Detailed Site Plan
Departure from Design Standards
Alternative Compliance
Dash In at Marlboro Pike #1552

DSP-21009
DDS-687
AC-21022

SUBJECT: Detailed Site Plan DSP-21009
 Departure from Design Standards DDS-687
 Alternative Compliance AC-21022
 Dash in at Marlboro Pike

Figure 1: Site Plan

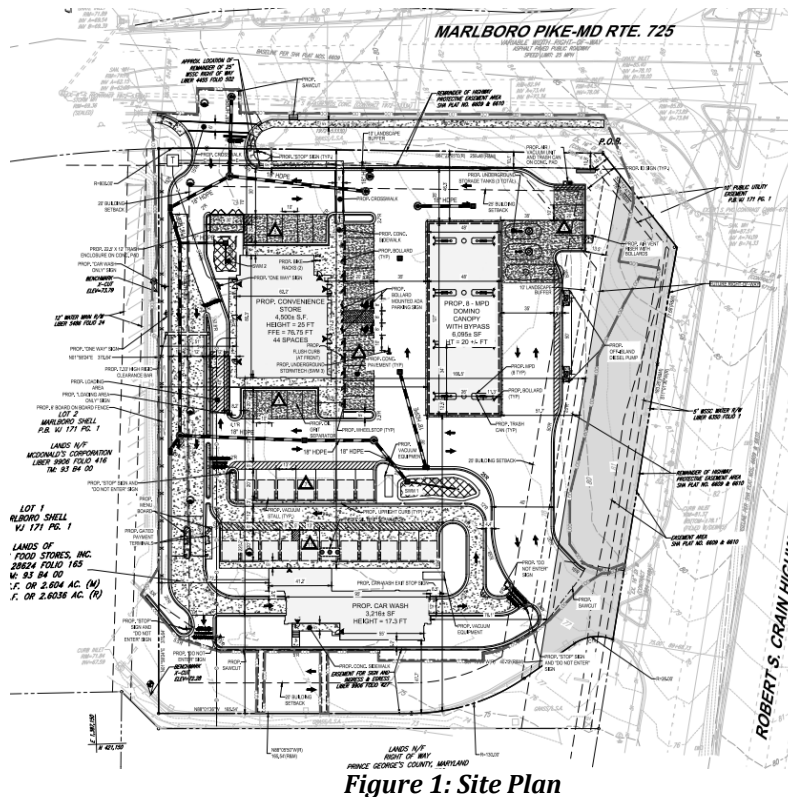
6. **Design Features:** This DSP proposes to construct a 4,508-square-foot food and beverage store, a gas station with eight multi-product fuel dispensers, and a 3,216-square-foot car wash. The site will have two access points: one located along MD 725 and one located along US 301. The proposed building and gas canopy are oriented facing US 301. The proposed plan shows dumpsters located behind the building on the northwest part of the site with a two-lane drive aisle leading to the car wash. The proposed 12-foot by 40-foot loading space is located between the rear of the building and the car wash drive aisle. The site is proposing a total of 44 parking spaces to include 2 handicap-accessible spaces and 2 bike racks. There will be 22 spaces that surround the food and beverage store and 4 additional spaces that are provided in the northeast corner of the site. There are 18 spaces that will also serve as vacuum stalls to accompany the car wash. A condition has been included herein, to request the removal of one parking space in front of food and beverage store to increase the width of the parking islands to provide additional trees to meet the landscape requirement.

As part of DSP-21009, the applicant filed a request for Alternative Compliance, AC-21022, relative to Sections 4.2.1, 4.3.1, 4.3-2, and 4.6 of the Landscape Manual. The applicant revised the landscape plan to meet the requirements of the Landscape Manual for Section 4.2, but has not yet satisfied Section 4.3. The site has an excess of parking spaces, and the Alternative Compliance Committee found that Section 4.3 could be satisfied with the removal of one parking space and the widening of the landscape islands to provide

- h. Add the street connection width for MD 725 (Marlboro Pike) to the site plan.
- i. Revise the landscape plan to conform to Section 4.3 by removing one parking space to the east of the food and beverage store, widening the planting islands five feet, and adding a shade tree to each island.
